From:	Kevin Slovarp
To:	Neil Miner; Jordan Hess; Dave DeGrandpre; Mirtha Becerra
Cc:	Emily Gluckin; Troy Monroe; Mary McCrea; Heidi West; Eran Pehan; Jeremy Keene; Donna Gaukler
Subject:	RE: Couple of questions/thoughts about mcnett flats
Date:	Monday, February 22, 2021 10:02:05 AM
Attachments:	Existing vs. proposed Pius Way improvements.pdf
	image003.png
	image004.png
	image005.ppg

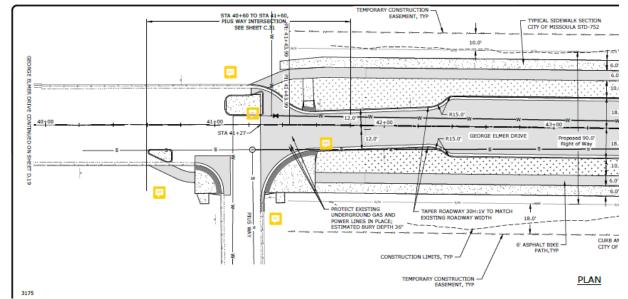
The below image shows we have an existing water main east of the Pius Way ROW. I would hope that we could work with the property owner(s) and be able to run a future trail within the existing water main easement as this land is already encumbered by the water main and associated easement.
